# RESIDENTIAL PLAN CORRECTION SHEET

**ADDENDUM to Permit No. 740-77**  
**Owner G. WATSON**  
**Location 505 EUCLID**

PROPOSED 12 X 12' ADDITION  
ON REAR OF 505 EUCLID ST.

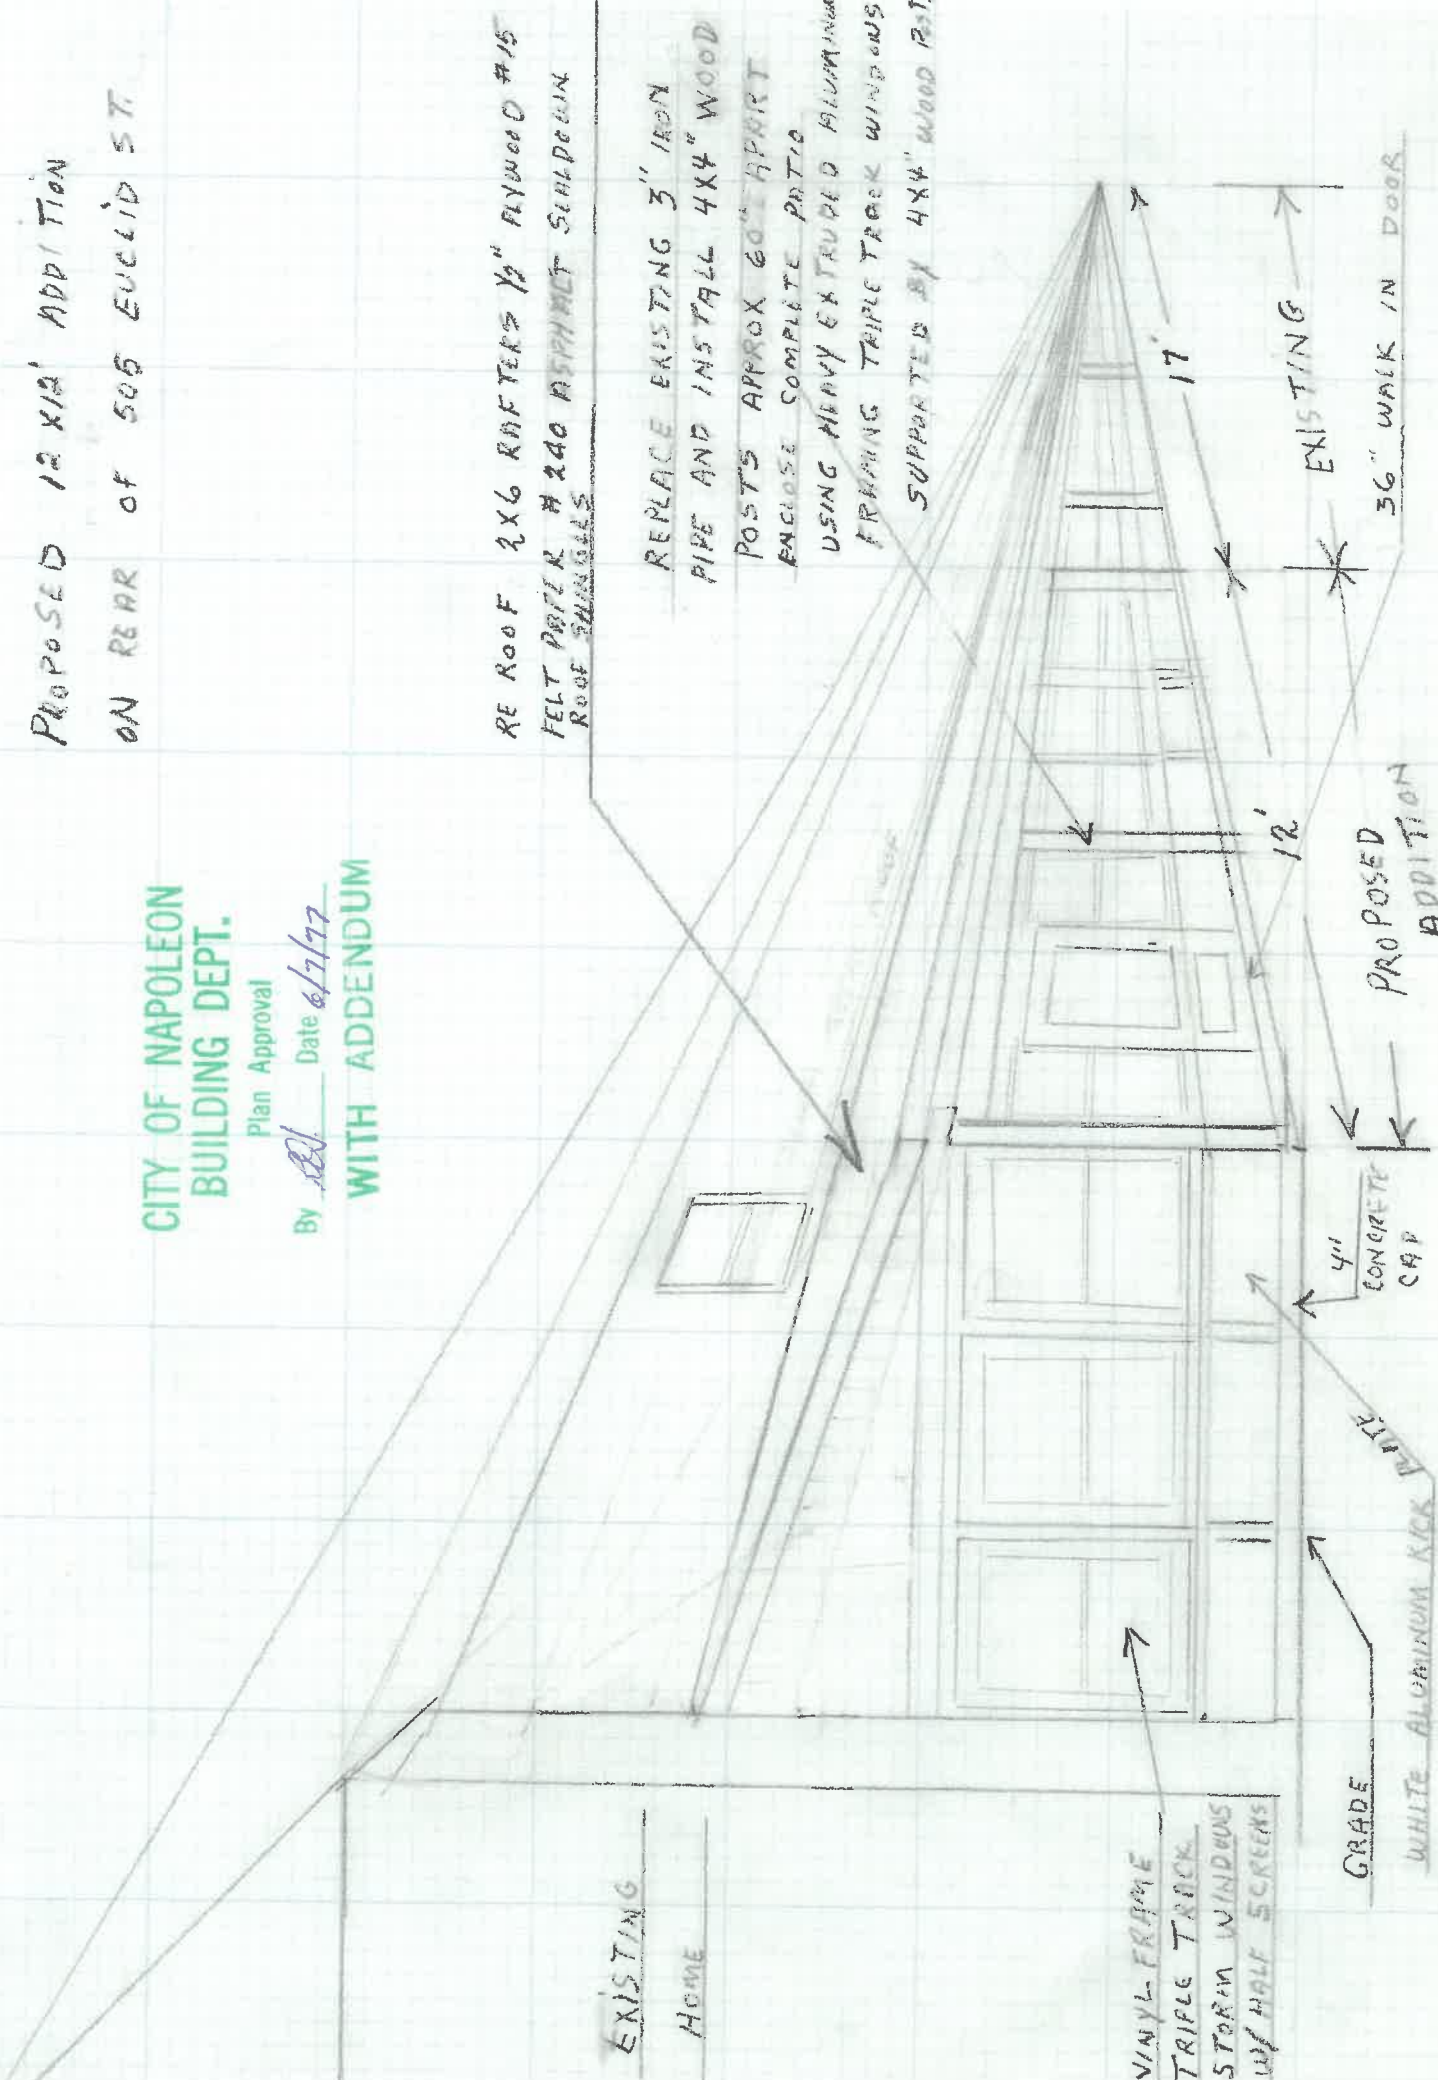
**ADDITIONAL CORRECTIONS:** ANCHOR PATIO COLUMNS IN APPROVED MANNER, WHERE NEW RAFTERS TIE INTO EXISTING HOUSE PROVIDE WOOD LEDGER OR JOIST HANGERS.
